Question Naugatuck-1:

Question Naugatuck-2:

TOWNWIDE SEWER MAP
OXFORD, CONNECTICUT

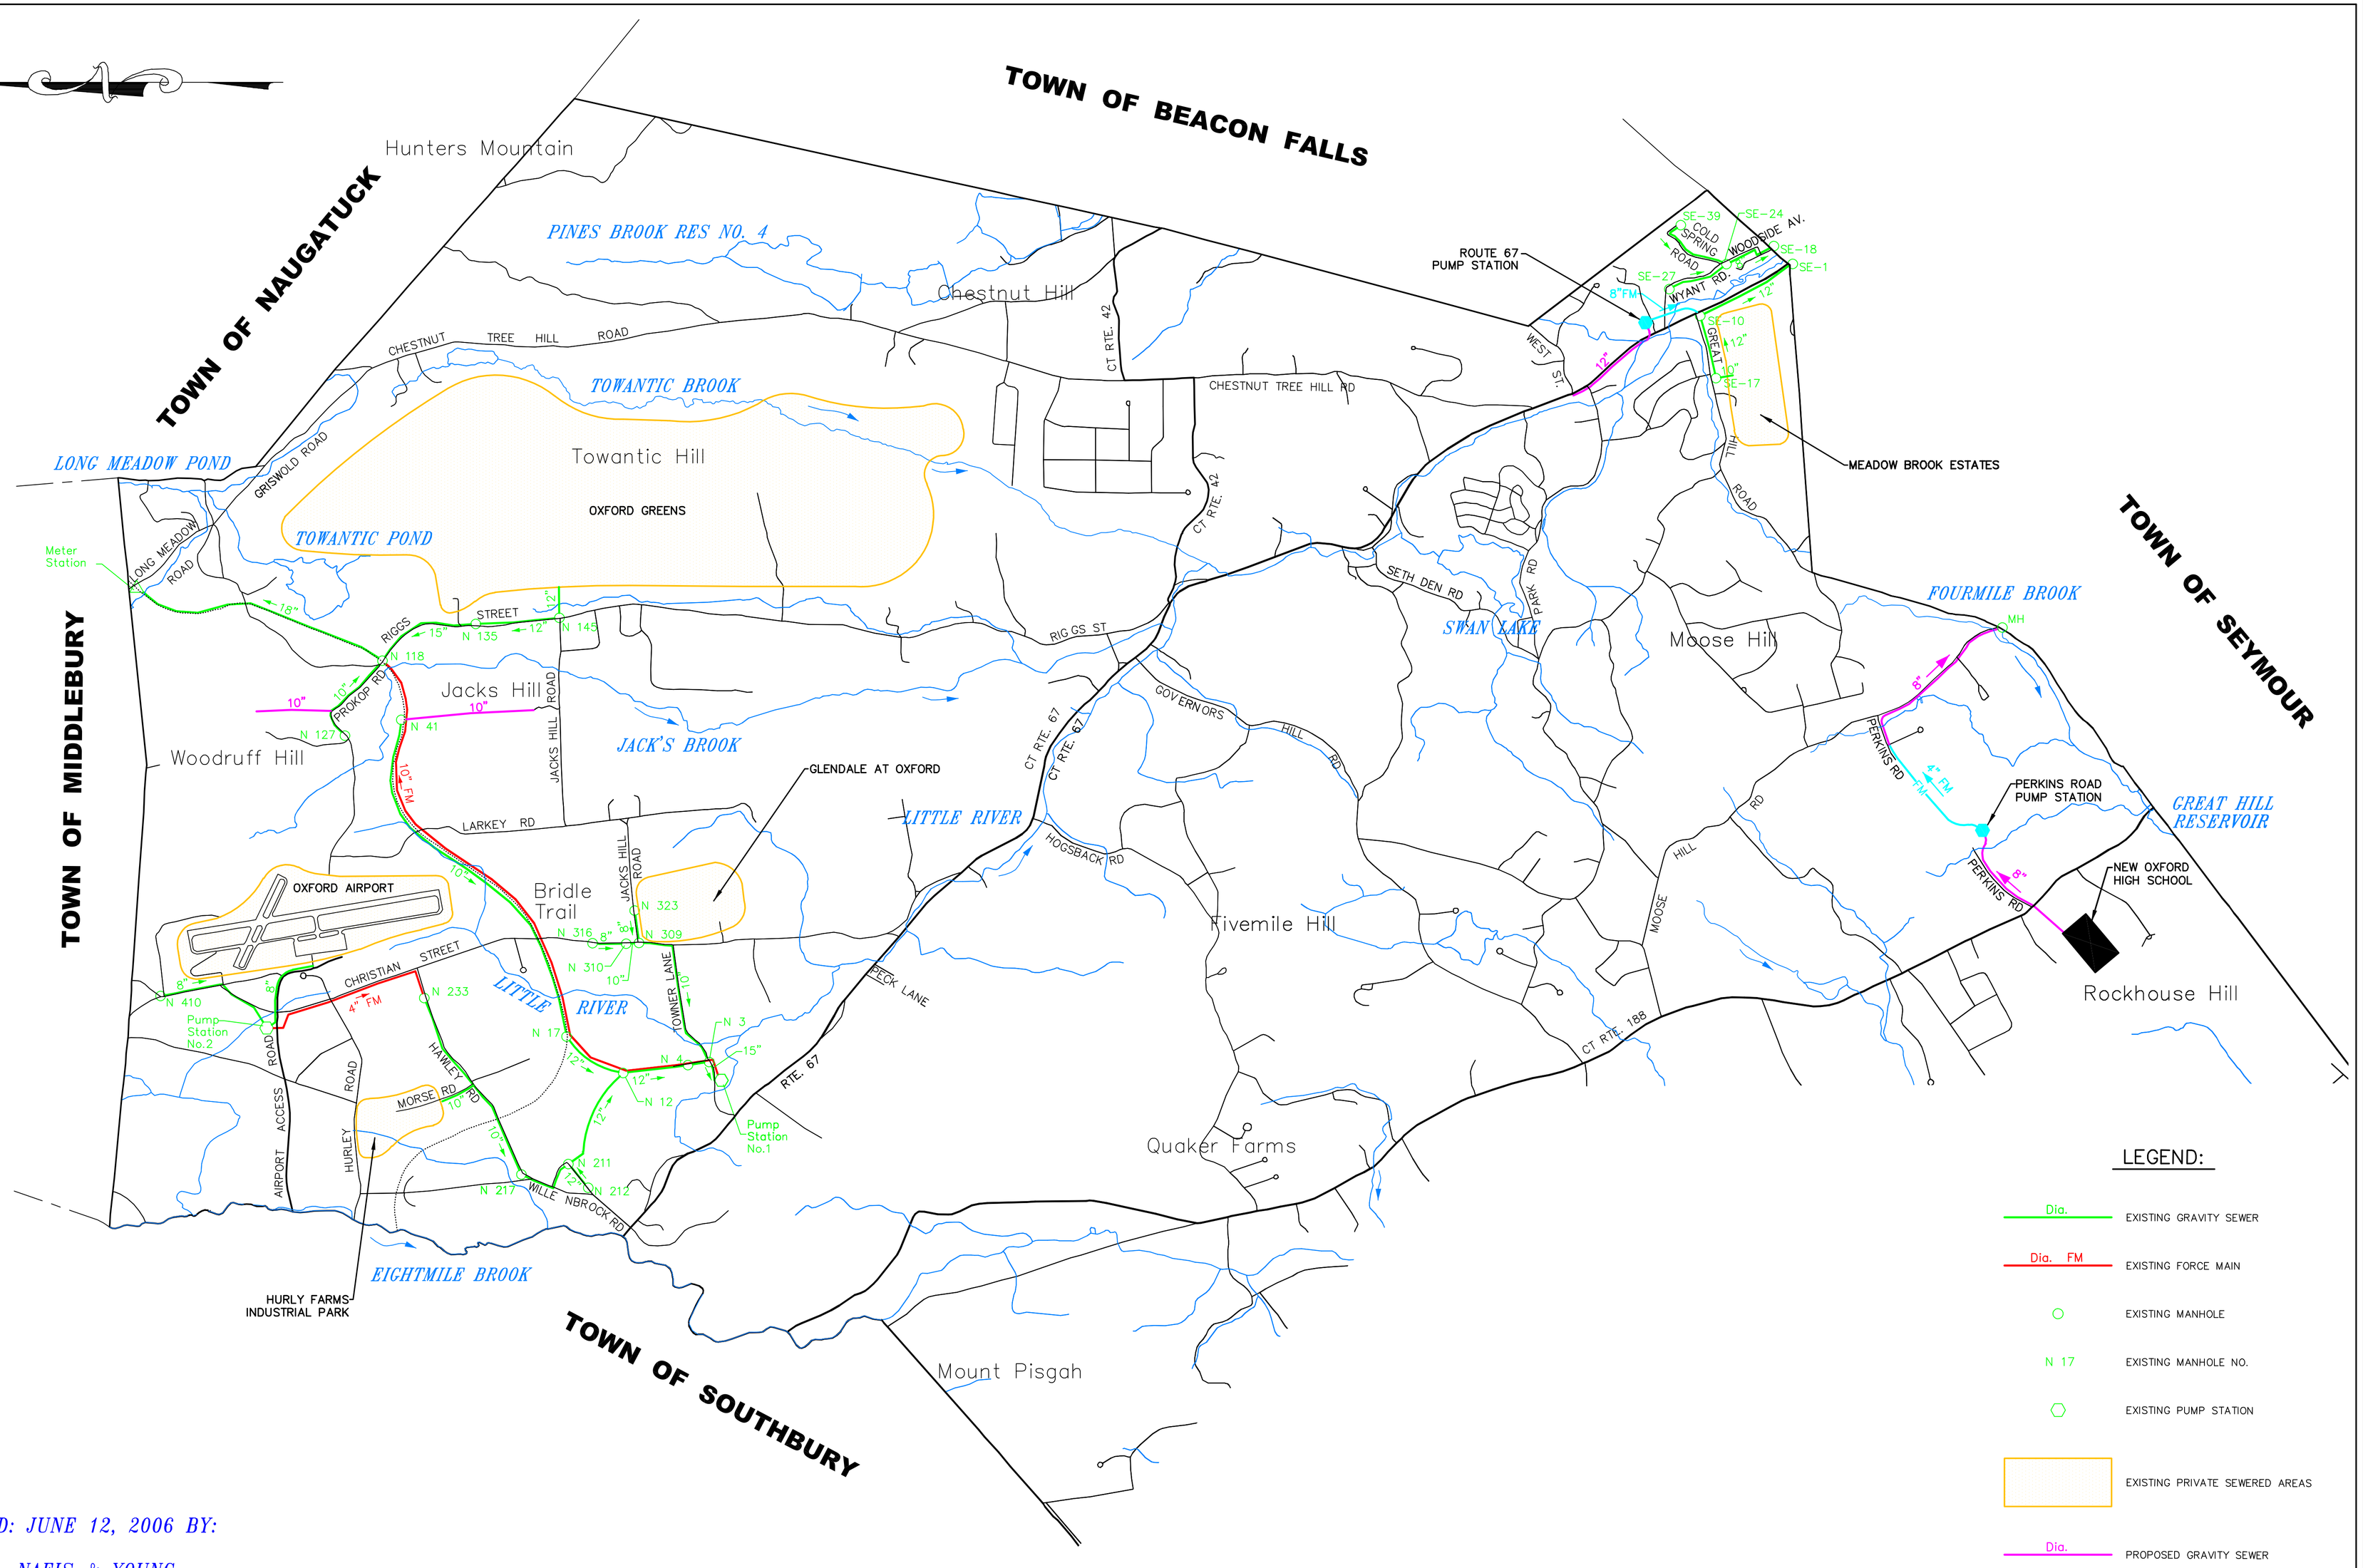
Describe in detail and provide a map, with descriptions of the sewer line including inspection film depicting the scoping of the course and capacity of the lines by which the wastewater discharged to the Oxford municipal sewer system travels to the Naugatuck Wastewater Treatment Plant.

CPV Towantic, LLC does not have the requested information because it does not own, or have the responsibility to operate and/or maintain the Town of Oxford's sewer system. Requests for specific information, such as capacities and inspection reports, should be directed to the Oxford WPCA Inspector or the Oxford Town Clerk.

CPV Towantic, LLC obtained the attached "Townwide Sewer Map, Oxford, Connecticut" from the Internet. We have done no independent evaluation of the accuracy of the map.

Given the relatively limited quantity of wastewater discharged by CPV Towantic (a maximum of 4.5 gallons per minute, which is roughly equivalent to the flow of a common garden hose), the course and capacity of the Town of Oxford sewer system were not evaluated by CPV Towantic, LLC.
